MANDATORY SERVICE BULLETIN

NO. MSB-42-039

Installation of a redesigned breather line and a new oil separator

WI-MSB-42-039

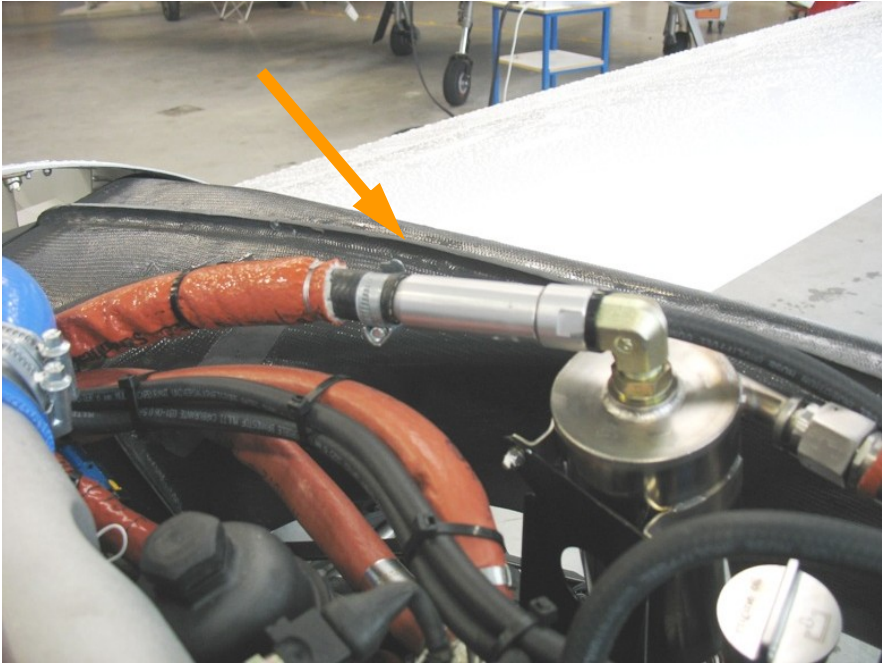
3	<p>Install new oil separator and new breather line according the following picture of this WI.</p> <p>Shorten breather line and fire sleeve as required and install breather line bypass (D60-7906-40-30 / D60-7906-40-31) acc. to picture.</p> 
4	Clean working area, check for foreign objects.
5	Check new installed items and all systems in working area for proper function.
6	Make appropriate entries into aircraft log.
